**Re: Response to Review Comments  
Highland Woods Subdivision  
MTR Development, LLC - Applicant**

**Town Engineer Review Comments – E-mail Dated May 16, 2019**

### HIGHLAND WOODS SUBDIVISION HIGHLAND CLIFF ROAD WINDHAM, MAINE

SPILLWAY RUN  
FILTER BASIN FB-2

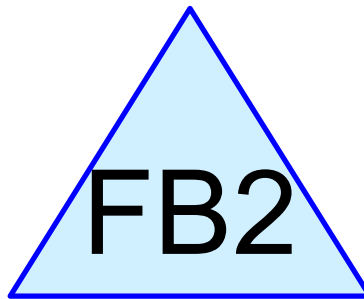
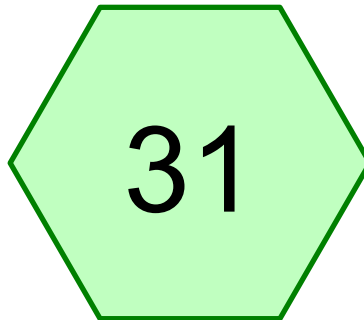
- a. The stormwater plan was previously reviewed (1/22/19) by Jonathan Earle and found to be in compliance with the Basic and General standards. However, please provide a spillway analysis for the underdrained soil filters for a 25-yr storm with the spillway as the sole outlet; it was not included.

Response: Included with this submission is an updated Stormwater Management Report which includes the spillway run model output. The top of berm elevations have been updated on the three (3) filter basins to provide a minimum of 12" freeboard modeled this way.

## EXISTING GRADE SKETCH - FILTER BASIN 1

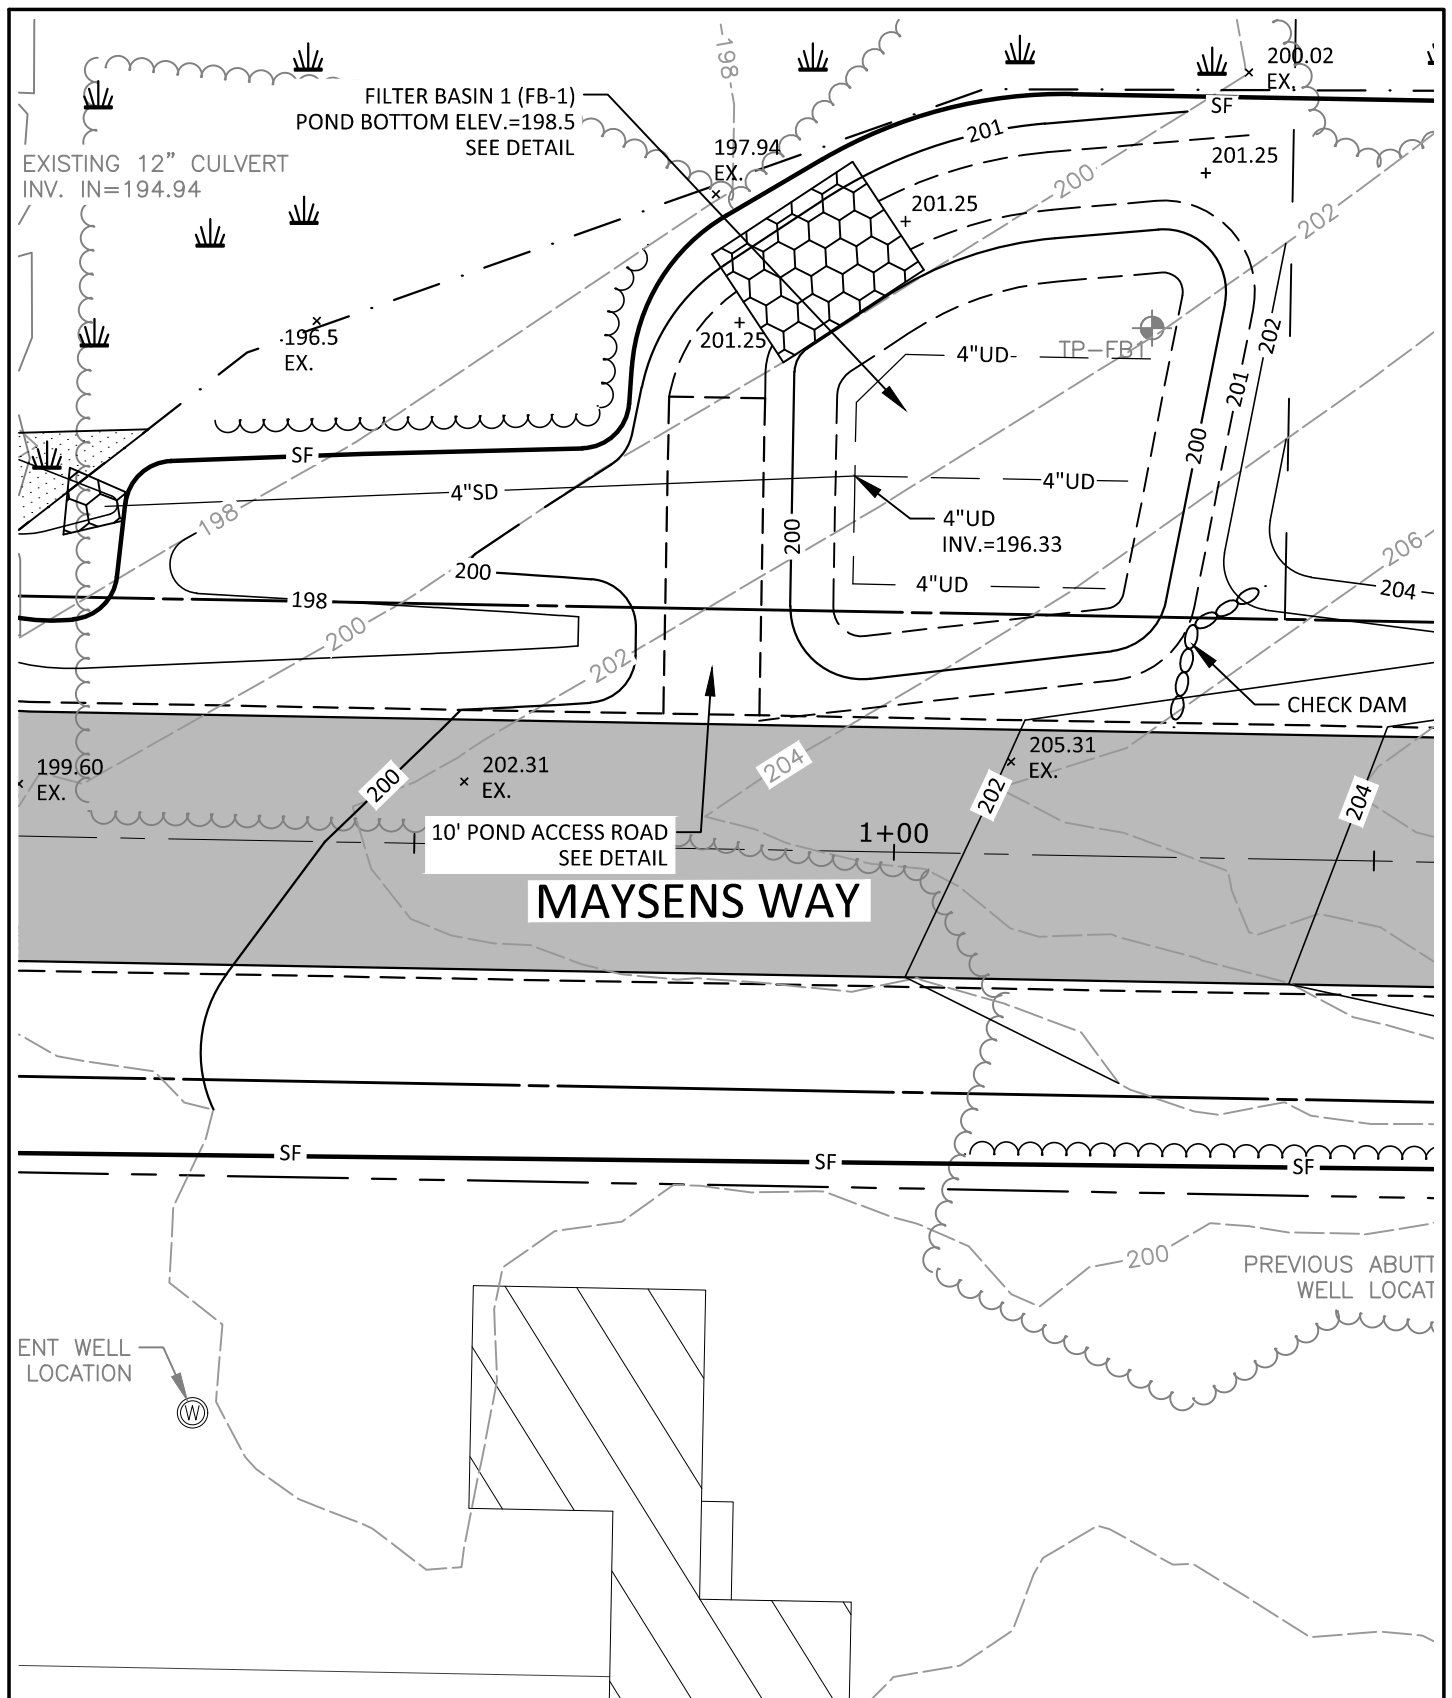
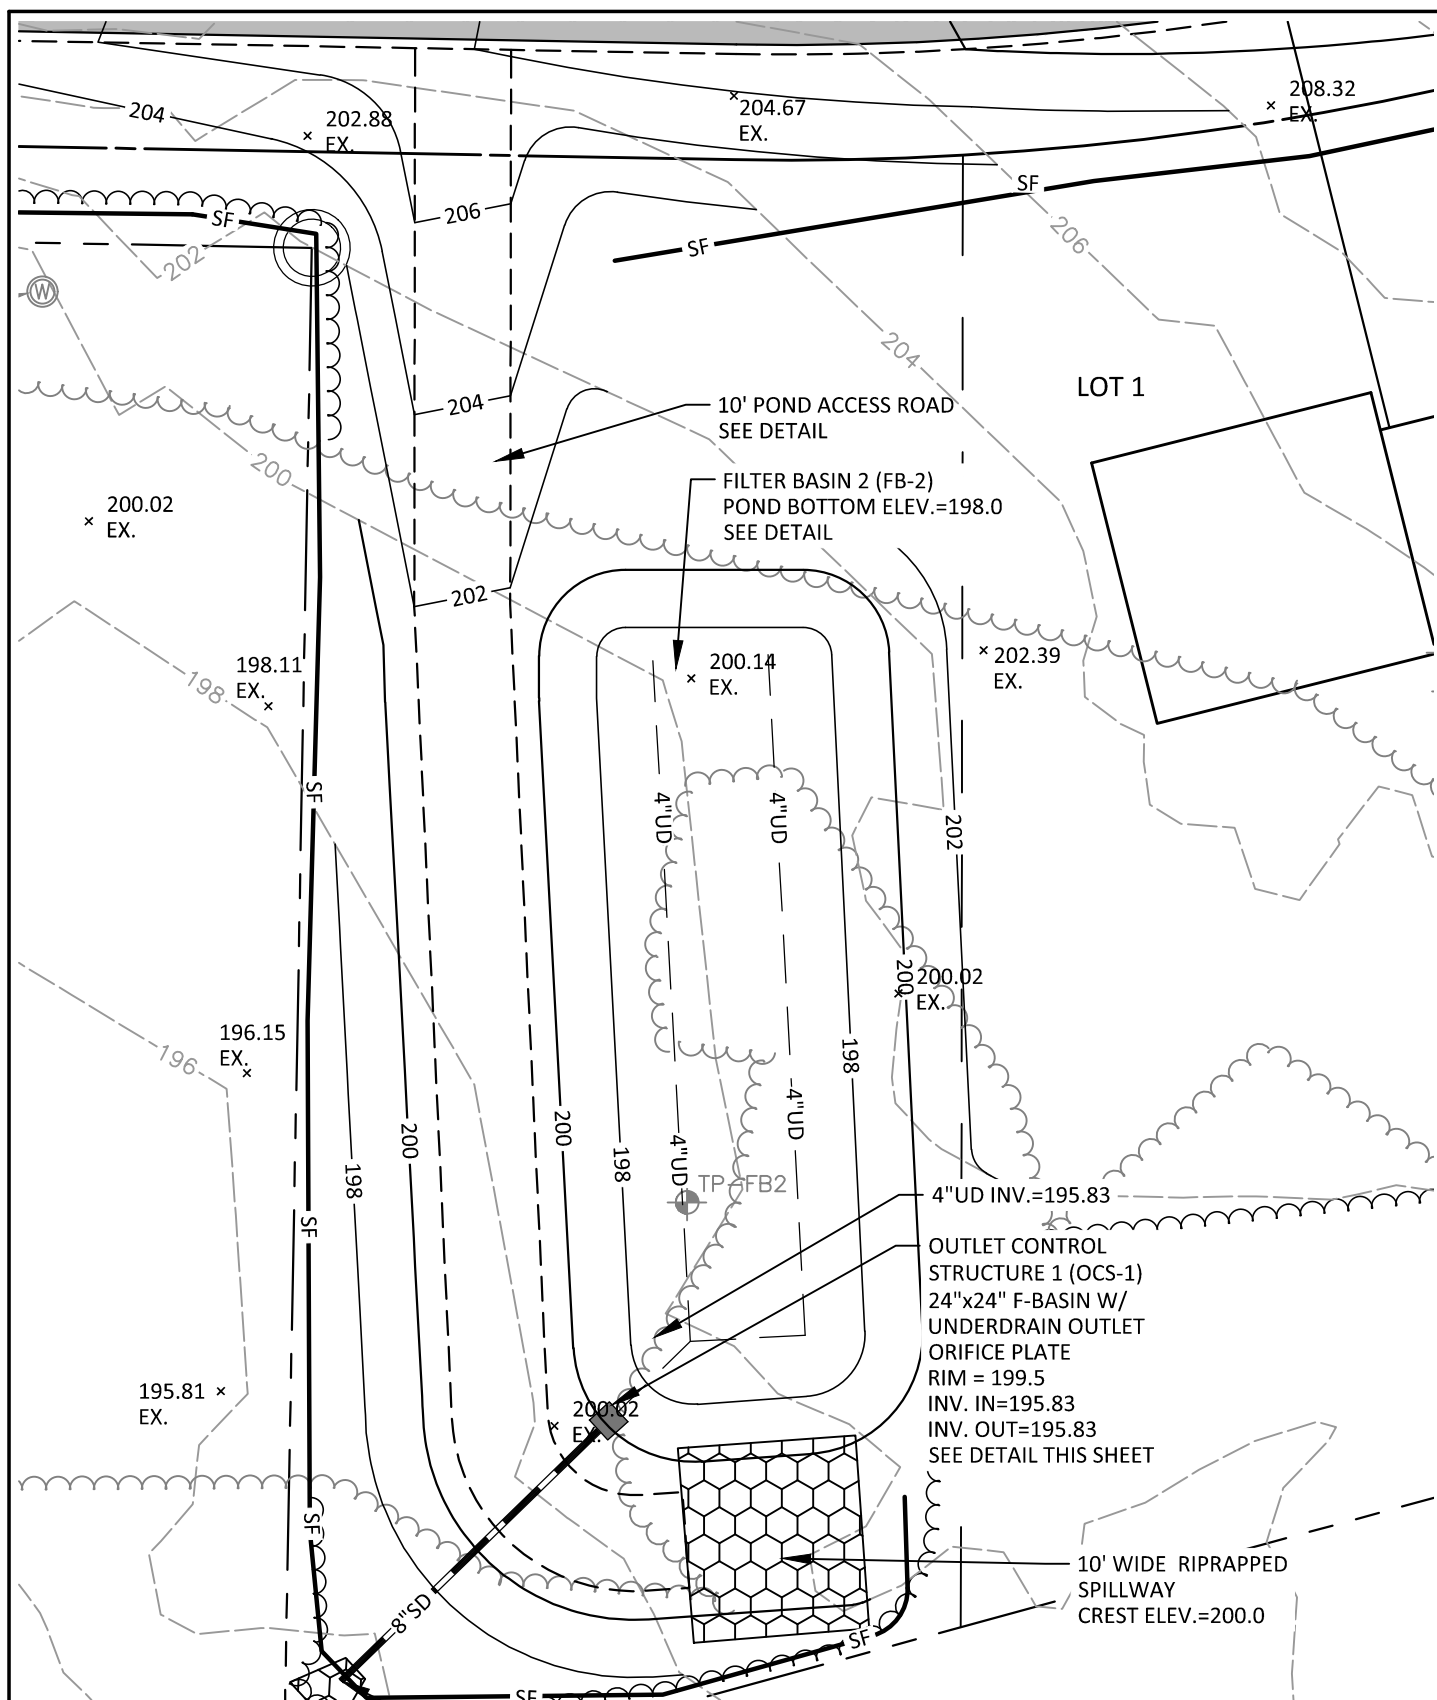
- b. Provide additional ground topography for the footprints for each of the 3 filter basins rather than relying solely LIDAR aerial survey as part of the final plan submission.

Response: Included are exhibits comparing the LIDAR survey with the on-the-ground survey performed by Survey, Inc. Underdrained Filter Basins FB-1 and FB-2 needed to be adjusted based on the results of the updated topography information.
